RE: CITY OF TUALATIN PLANNING COMMISSION HEARING 12-2-2021

Autumn Sunrise Conditional Use Permit (CUP) 21-0001

Autumn Sunrise Subdivision (SB) 21-0001

Lennar Northwest, Inc. & Applicant's Consultant: AKS Engineering & Forestry, LLC

STORM OUTFALL #7 PLAN AND PROFILE

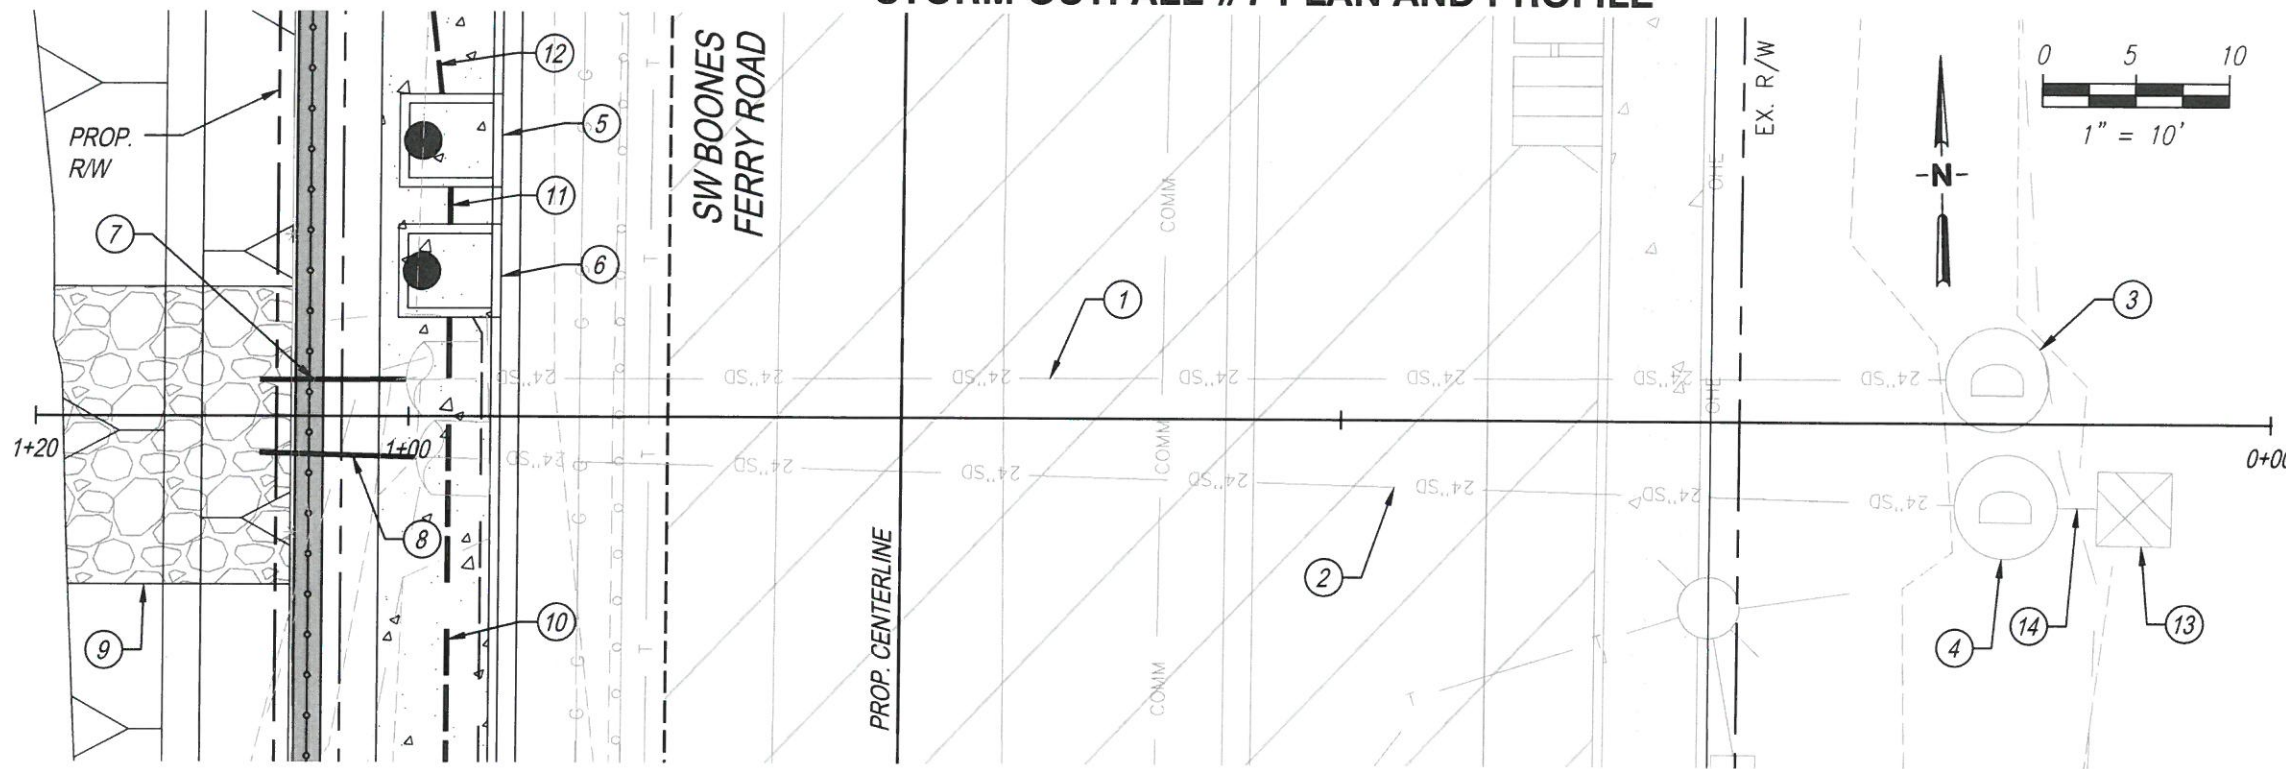
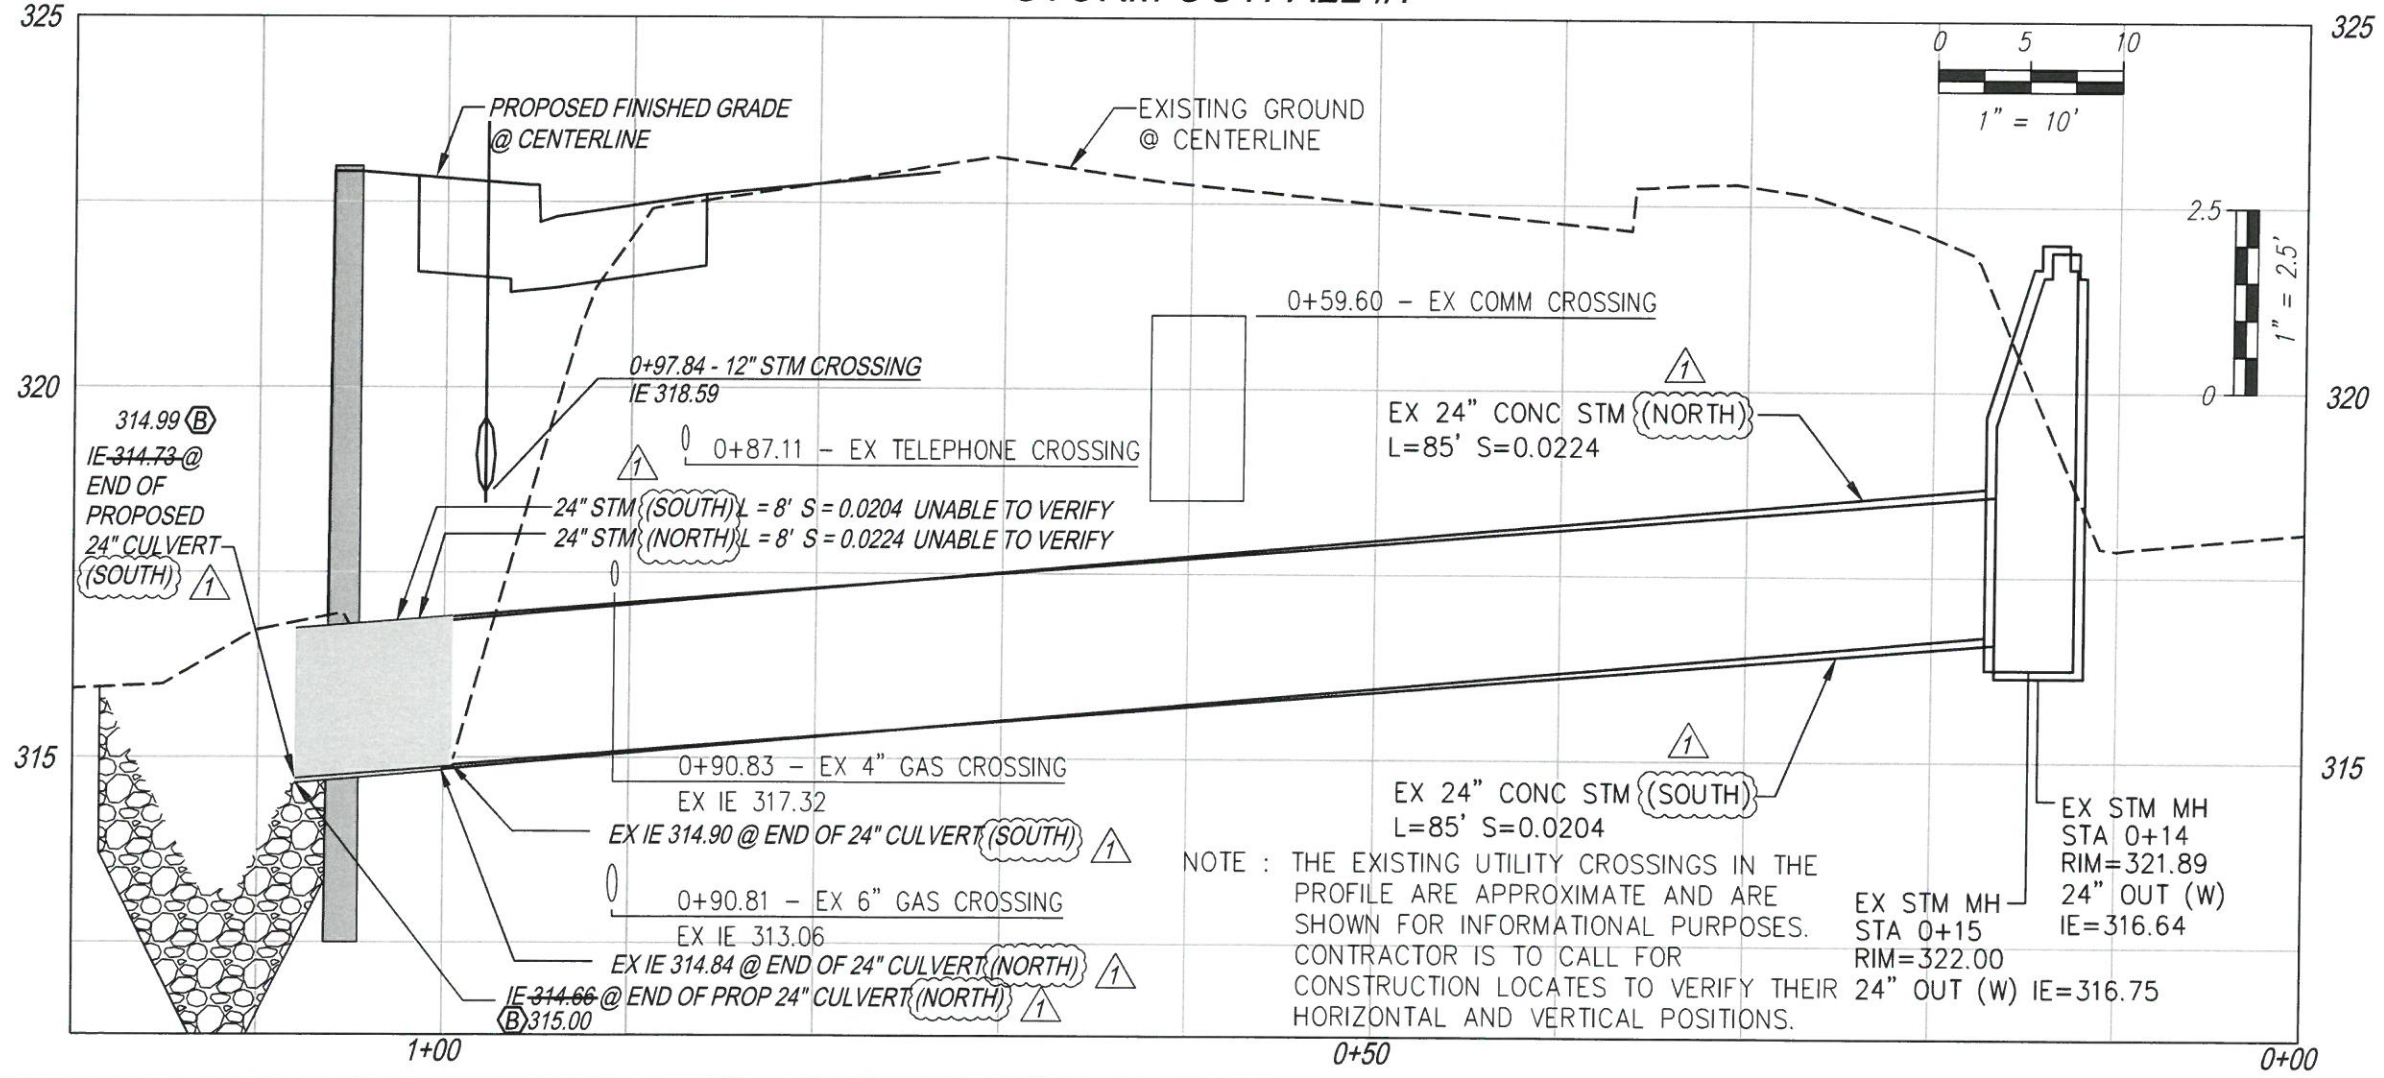
- The proposed stormwater pond in the SW portion of the AS development will collect and hold the AS runoff through periods of storm events. The County's Storm Outfall #7 (see Appendix C) is an existing 24-inch pipe that will serve as the pond discharge facility. This is a concrete pipe passing under SW Boones Ferry Road. It discharges directly into a wetland. Storm flows in the outfall will be directly affected by the AS pond operation.
- No detailed drawings of the stormwater pond outlet structure were provided in the Autumn Sunrise Plans. There is no assurance that the stormwater pond storage will operate as assumed in the model.
